INFORMATION REQUEST

APPLICATION NO: COM/42/2025
PROPERTY ADDRESS: 2-18 LINDENTHAL ROAD, PARK RIDGE QLD 4125
PROPERTY DESCRIPTION: LOT 31 SP 191861
APPLICATION DESCRIPTION:

• COMBINED APPLICATION - RECONFIGURING A LOT (1 LOT INTO 22 LOTS) AND VARIATION REQUEST TO VARY THE EFFECT OF THE LOGAN PLANNING SCHEME 2015

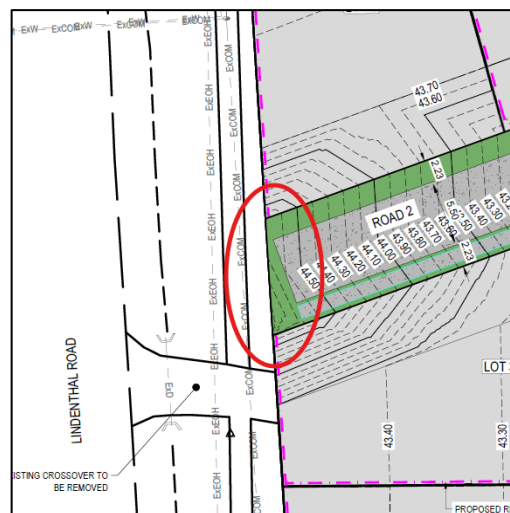
- 2.5. Provide civil plans to show land dedication for Park Ridge Road and Lindenthal Road consistent with Council's concept plans.

Advice Note: The site levels along Park Ridge Road and Lindenthal Road are to be consistent with the future road levels provided in the preliminary road design, or land dedication for batters will be required. Any additional land dedication for batters is required to be shown on the plans of development. Any required retaining walls are required to be shown on the concept engineering plans.
